October 31, 1984

Crystal River Unit 3 (CR-3)

Responses to NRC Letter Concerning Inservice Testing of Pump and Valves

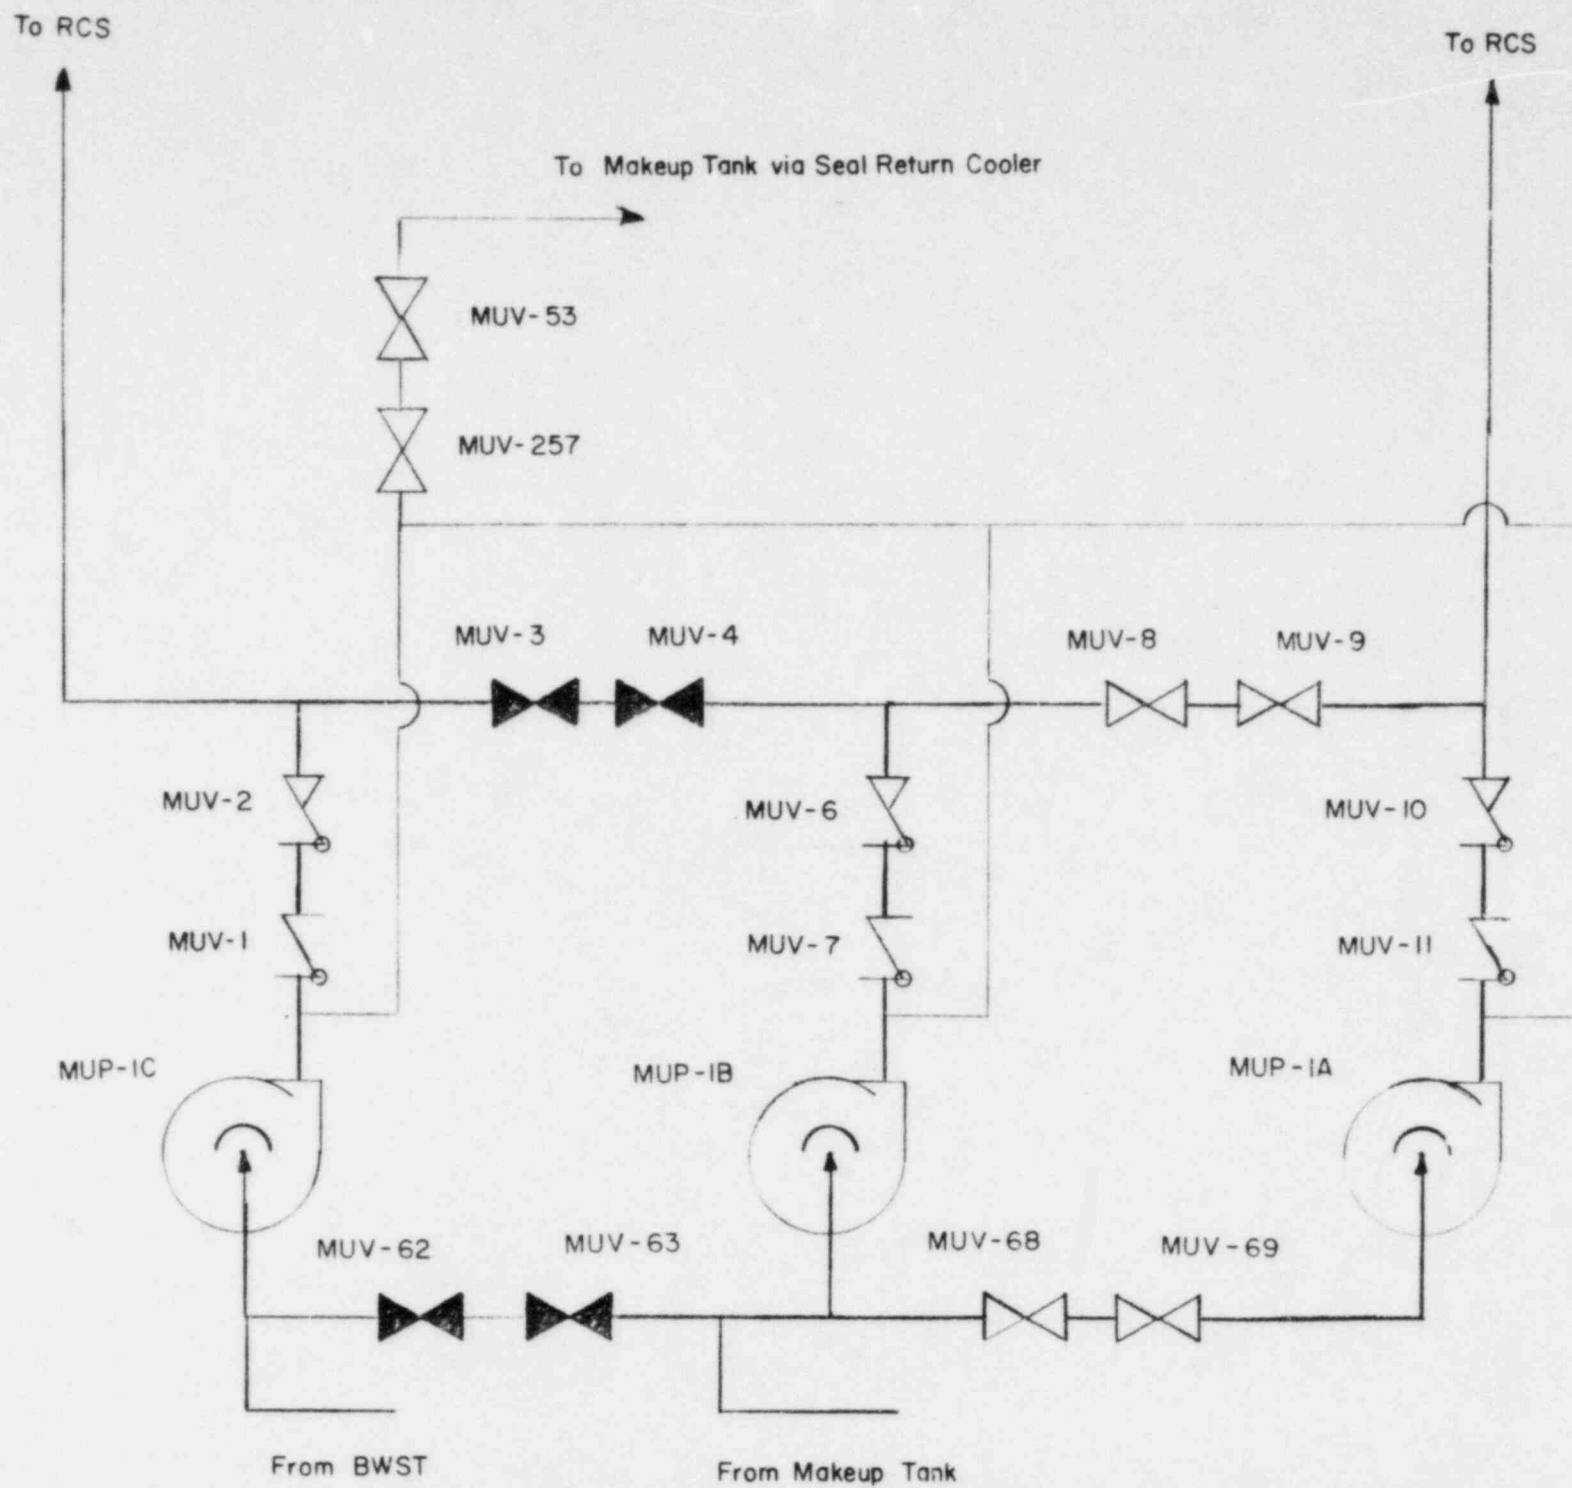
- R5. A change to the quarterly valve stroking procedure has been initiated. This change will add valve DHV-91 to this procedure.
- Q6. The licensee has requested specific relief from the exercising requirements of Section XI for valves MUV-53 and 257, makeup pump minimum flow recirculation valves, and has proposed to exercise these valves at cold shutdown. The licensee states that stroking of these valves during normal plant operation would interrupt minimum recirculation flow on the running makeup pump. Should the valve fail in the closed position, damage would result to the makeup (high pressure injection) pump. We do not agree with the licensee's basis and, therefore, conclude that relief should not be granted. The licensee has stated that pump damage could result if the valve fails closed on the running pump. However, we have concluded that operation of the pumps could be shifted and testing conducted per Section XI.

- R6. The minimum flow path, from the makeup pumps to the makeup tank is through series valves MUV-53 and MUV-257. Closure of either valve would isolate the common header for all three makeup pumps to the minimum recirculation flow path. Isolation of this flow path would result in pump damage. A simplified sketch has been provided for clarity. Florida Power Corporation, therefore, requests that the relief be granted.

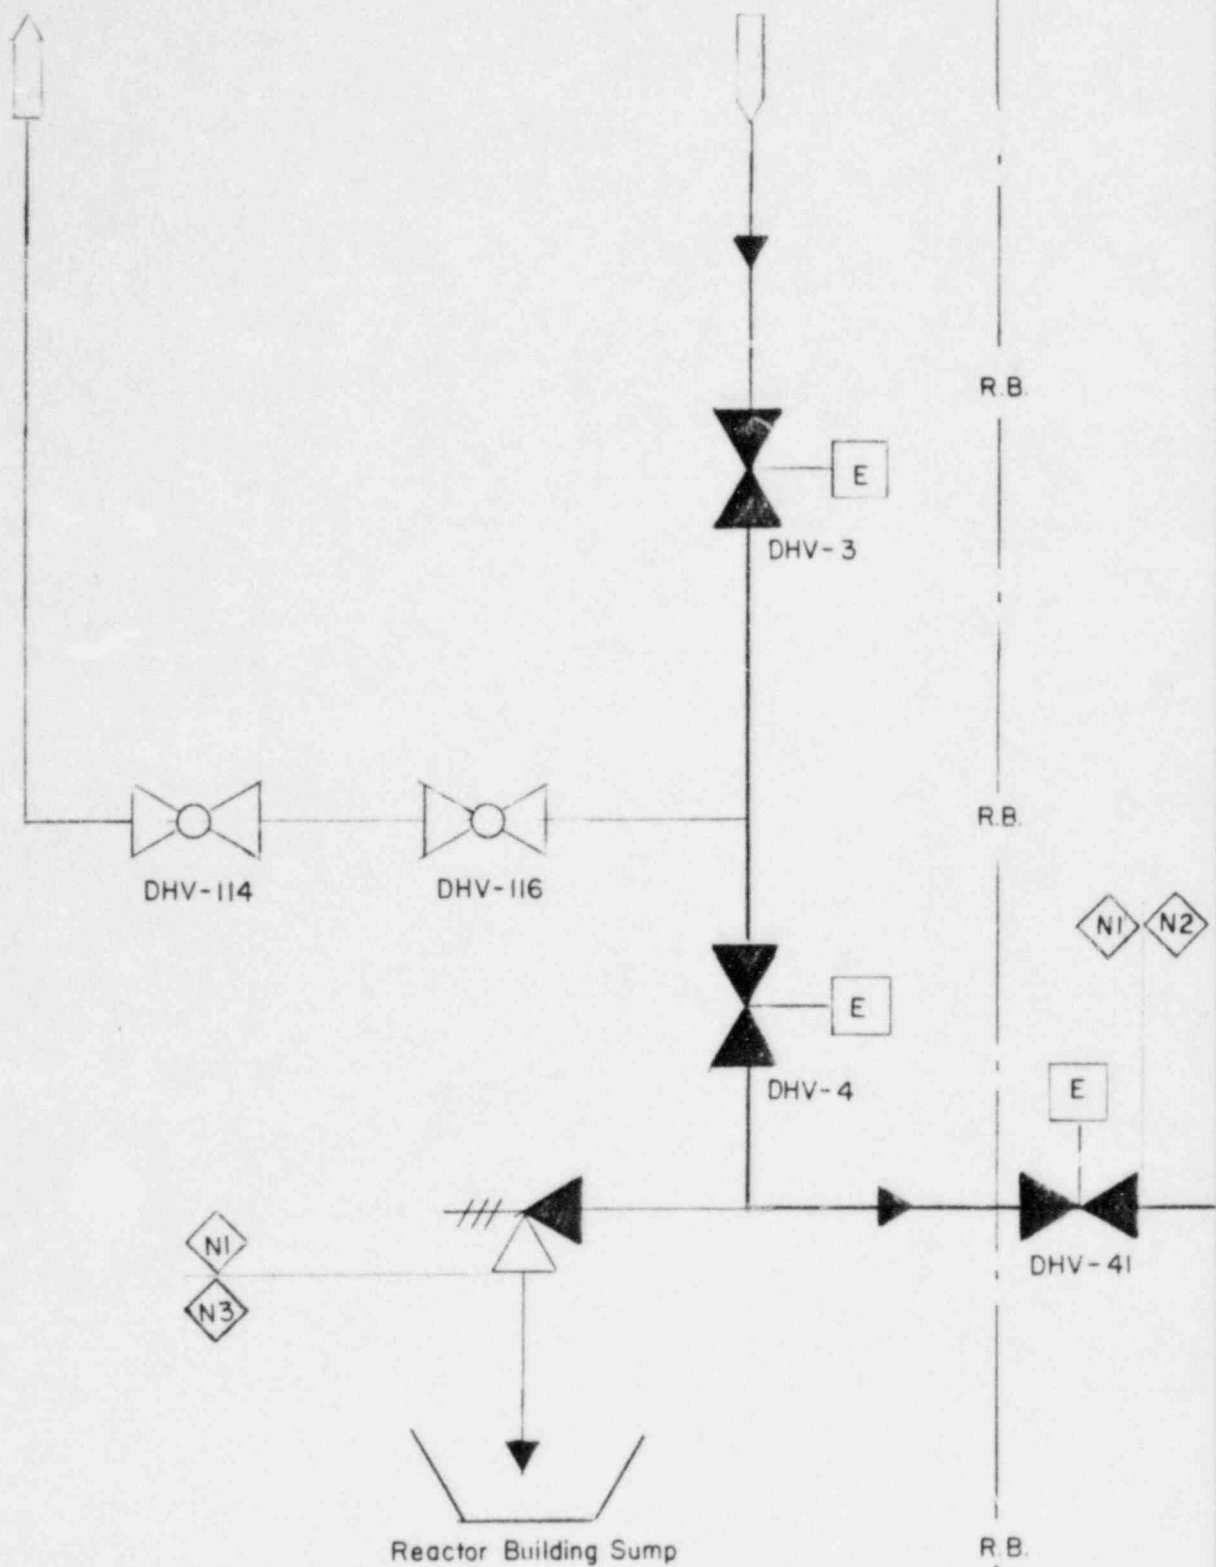
- Q16. The licensee has requested relief from the leak rate testing requirements for the following pressure isolation valves. It is the licensee's intention to use installed instrumentation to monitor valve leak tight integrity. However, the proposed method does not provide adequate assurance that the leak tight integrity of each valve is verified individually.

Valves DHV-3 and DHV-4 have an engineered system installed such that seat leakage in the closed position is inconsequential for the fulfillment of their function. Seat leakage of valve DHV-3 can flow into Class 1 piping. The only paths available for the leakage from this piping are through valve DHV-116 to the higher pressure reactor vessel or through valve DHV-4. Any seat leakage of DHV-4 will flow into the Reactor Building dump. Seat leakage of the valves will not degrade the ability of the valves to perform their function. A figure depicting these possible leakage paths is attached. Therefore, they are not category "A" valves.

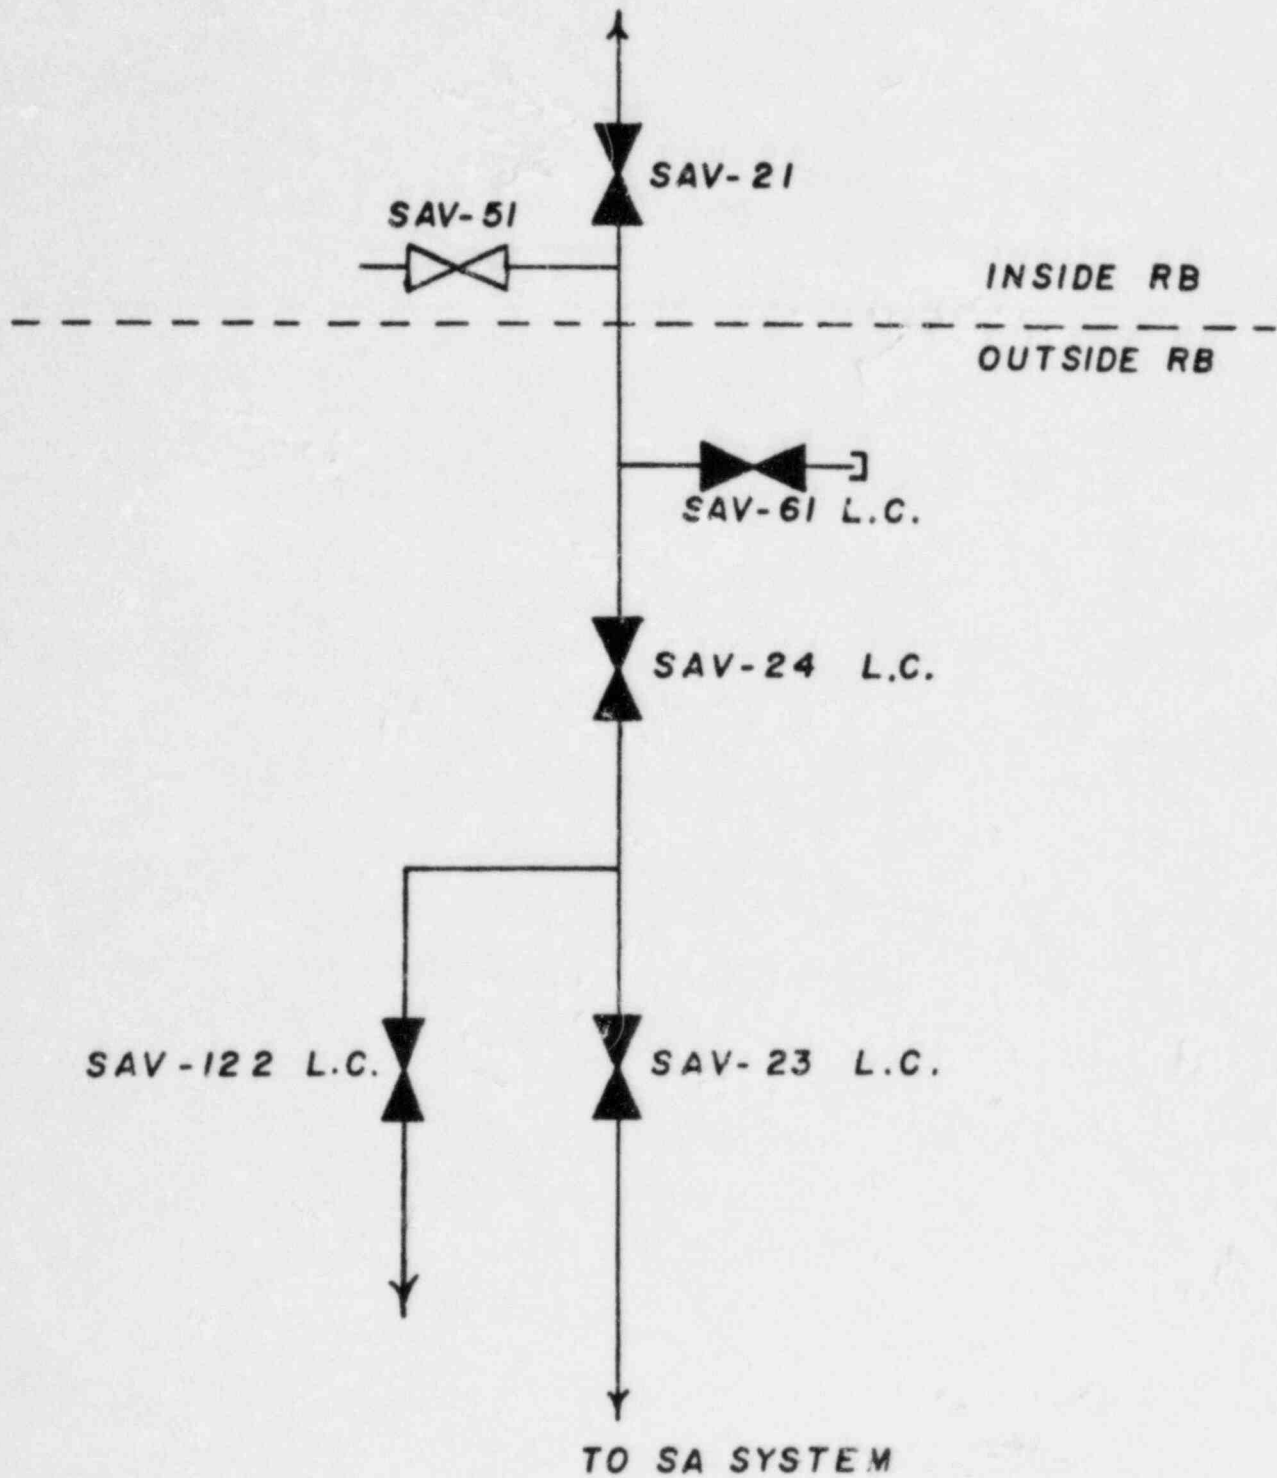
Q20. In the working meeting the licensee agreed to change SAV-23 from Category E to Category A/E (P-2); this change was not made in the resubmittal program. Our position is that the ISI program should be revised to reflect the A/E categorization of valve SAV-23.

R20. The NRC position is based on the temporary Post-Accident Sampling System (PASS) configuration that was employed at CR-3 until the permanent system could be installed. The installation of the permanent system has been completed, therefore, the original definition of valve SAV-23 in the program is correct. A figure showing the permanent configuration is attached. No changes to the program are needed.
